# K8T890A01

Version 1.0

VIA K8T890 CF + VT8237/ R / R Plus Chipset  
AMD AM2 Processor

# Clock Synthesizer

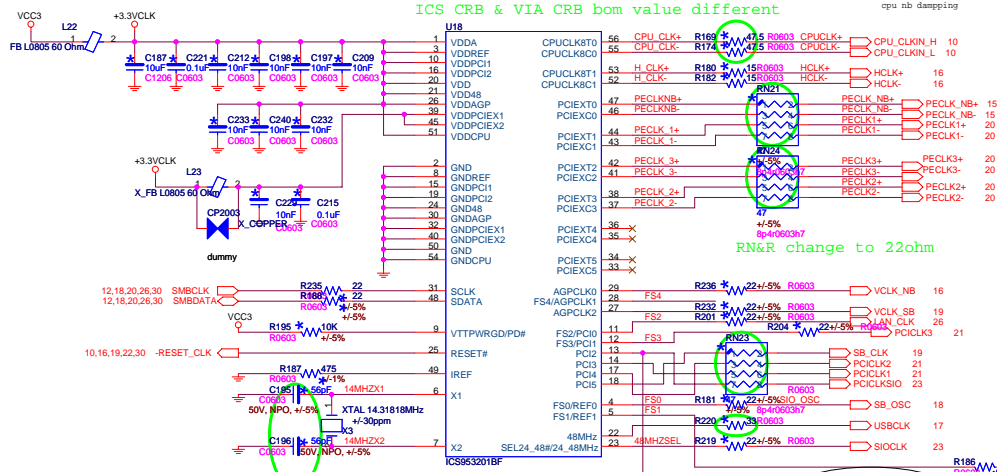
Delete RN26 , RN27

ICS CRB & VIA CRB bom value different

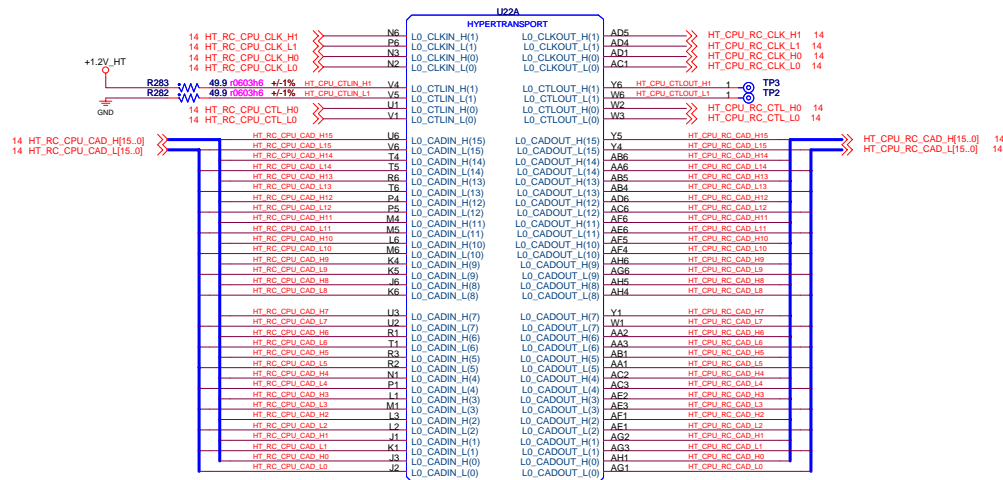
CHECK VIA ICS CRB & VIA CRB bom value different

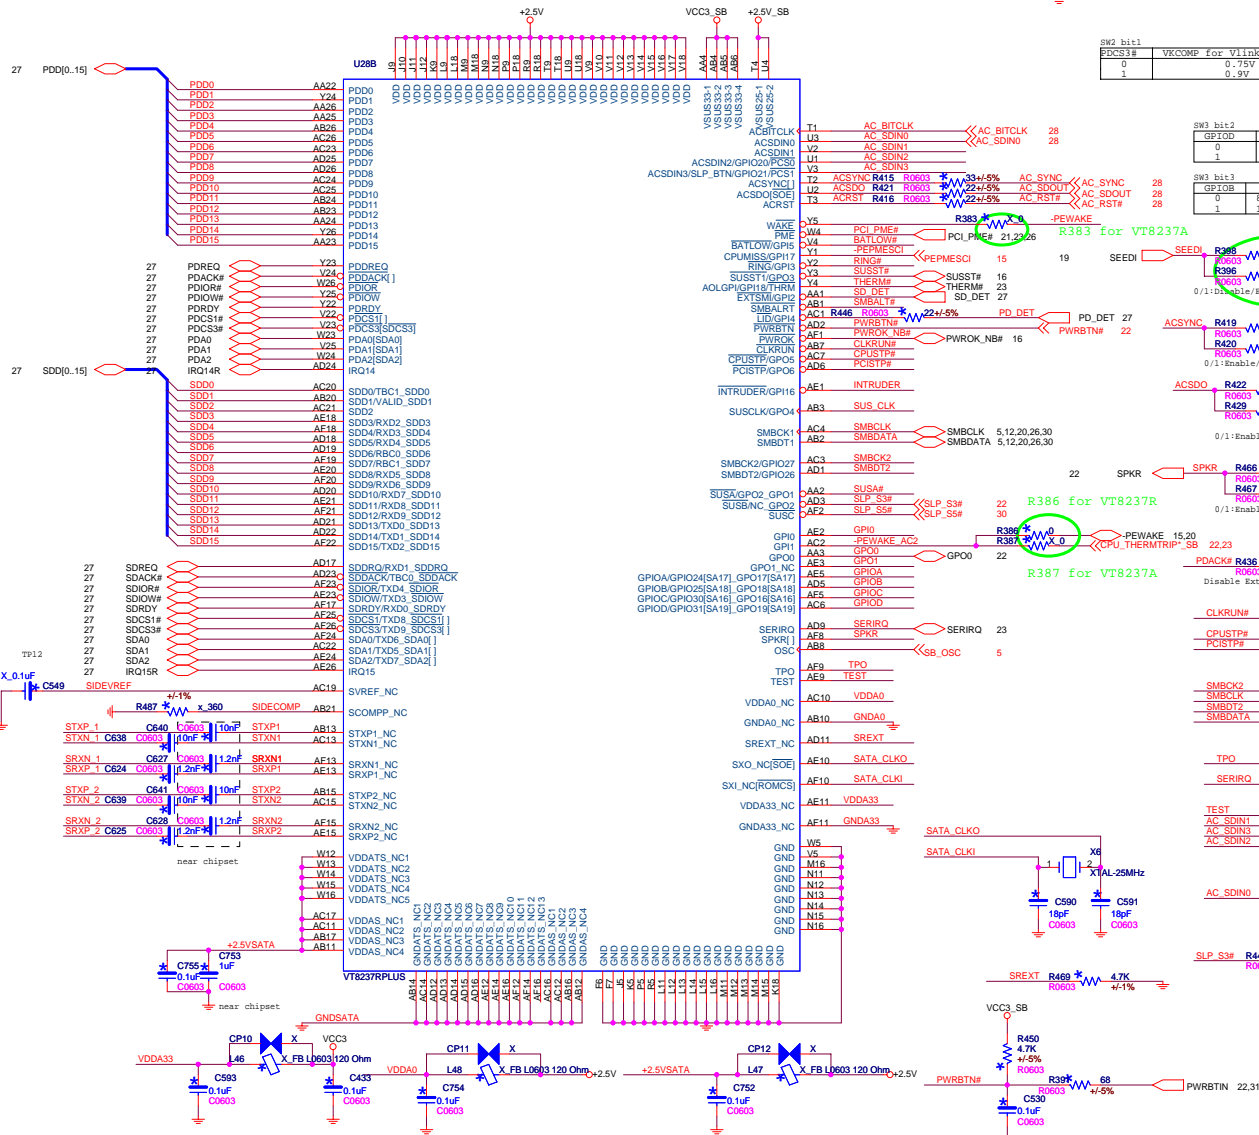
change from 0 ohm to 2.7k ohm

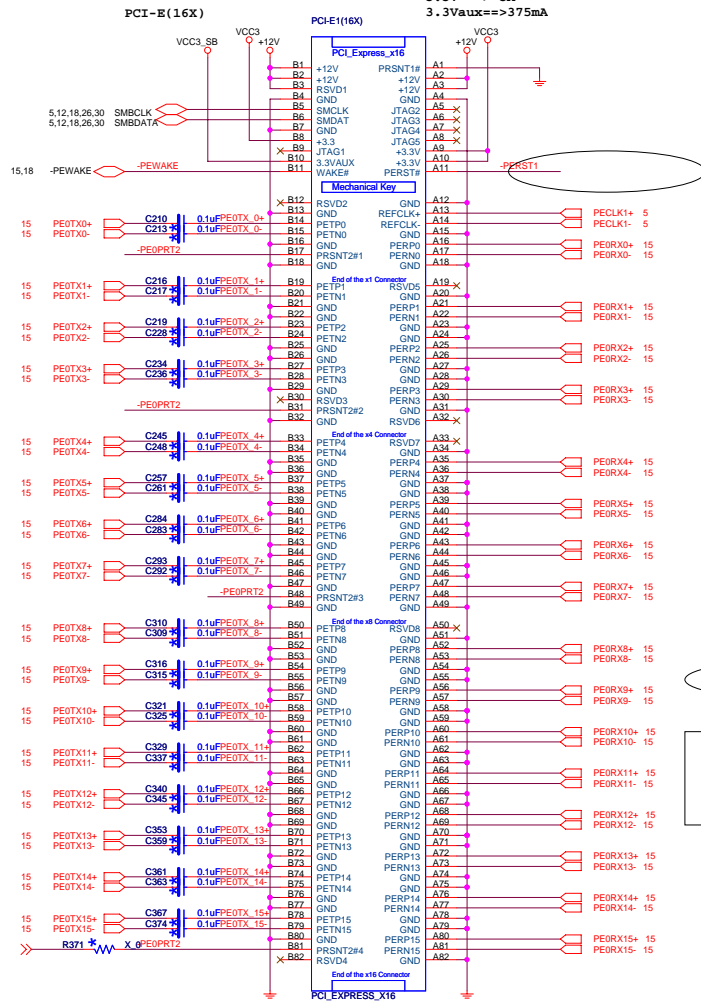
C181 CHANGE 470U TO 1000UF

# REAR PANEL USB CONNECTOR FOR USB PORT 0,1

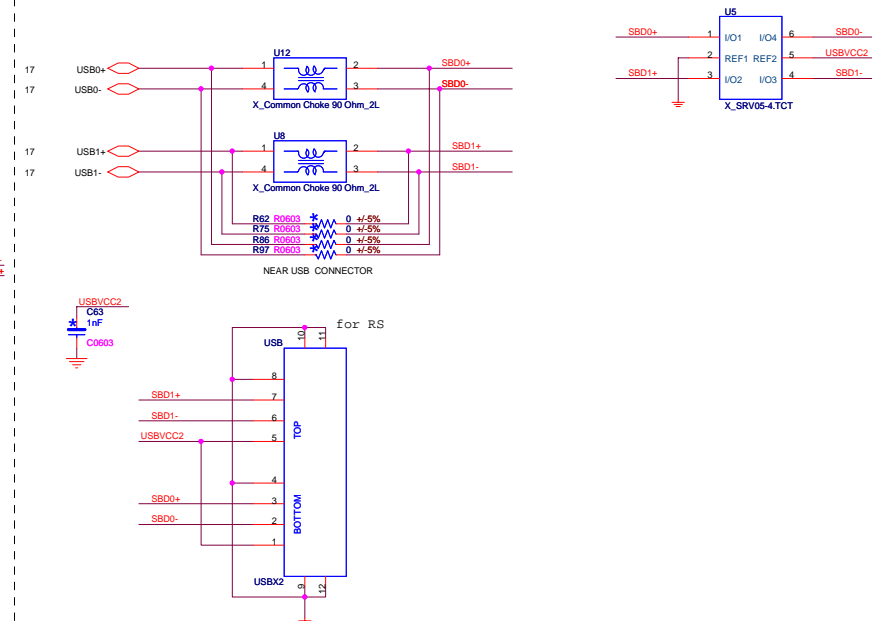
Add 10 pcs cap (dummy)
